विषय:- Diversion of 0.7875 Ha. (Revised area 0.9060 ha.) Forest land For Construction of Missing link road from "Laxmangarh-Salasar to Rajas Via Chouhano ki dhani, Gouru ka bas, Khejaroliyan ki dhani & Miyan ki Dhani" in Rajas P.F., Range Laxmangharh, Village-Rajas, Tehsil-Laxamgarh, Distt-Sikar (Raj.)

(Proposal no. FP/RJ/ROAD/33785/2018)

Alternative Route Analysis Report

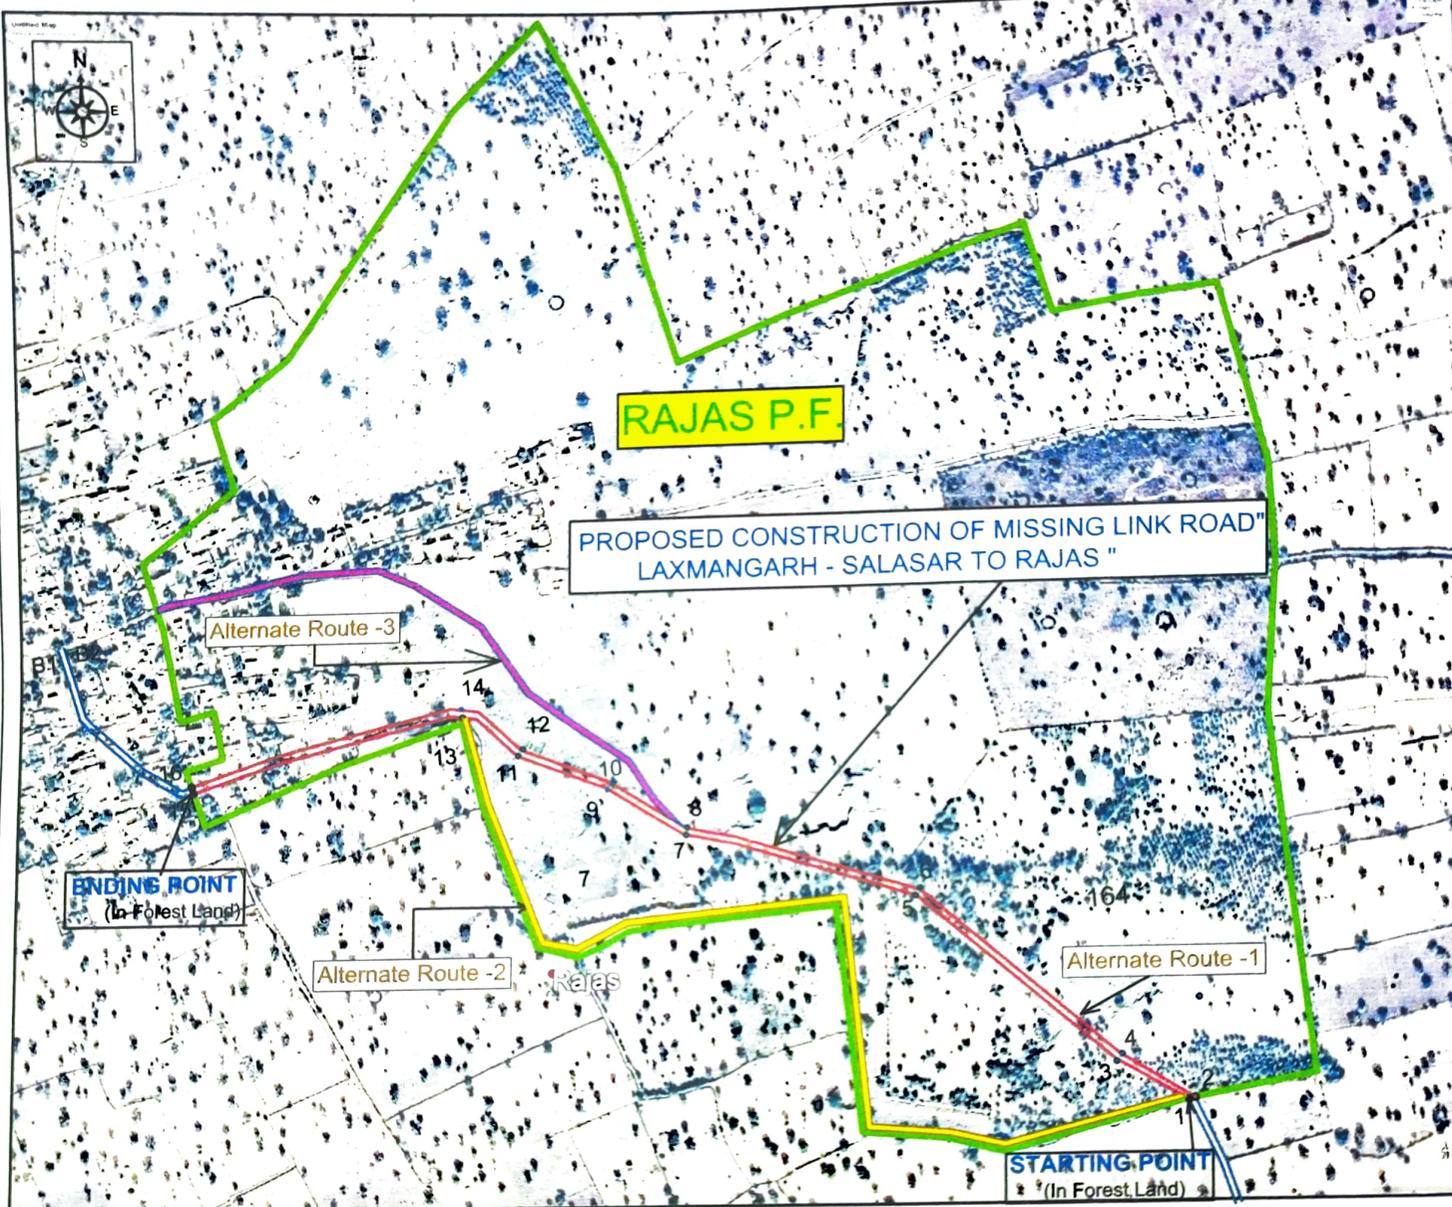
S.No.	Essential details sought	Reply
1	There is another pucca road passing through the forest block which seems to be constructed between 2013-2015 by google image. Please provide the diversion details of this road.	The another pucca road passing through the forest block was constructed before 1980 and it has been recarpeted in the year 2010. (Copy of sanction attached) As it was old pucca road constructed before 1980, (Letter of gramPanchayat attached) hence no diversion was needed.
2	DCF has to make sure that the length of the road within the forest area should be minimum, but in this case it is not explored.	Besides this road, two other alternatives have been explored. The proposed road requires minimum forest land for diversion. (Copy attached) This Route connects scattered habitation of various Dhani's namely Chouhano ki Dhani, Goru ka Bas, Khejroliyan ki Dhani & Miyan ki Dhani to Panchayat head quarter Rajas. Hence this route requires minimum diversion area & suits all parameters.

Route No. 01

Particulars	Width X Length	In Forest	Remarks
Proposed road in Forest area	7.5 Meter X 1208 Meter	9060 sq. Meter (0.9060 Ha.)	Minimum area required for diversion.

Route No. 02

Particulars	Width X Length	In Forest	Remarks
Proposed road in Forest area	7.5 Meter X 1522 Meter	11415 sq. Meter (1.1415 Ha.)

Route No. 03

Particulars	Width X Length	In Forest	Remarks
Proposed road in Forest area	7.5 Meter X 1373 Meter	10305 sq. Meter (1.0305 Ha.)
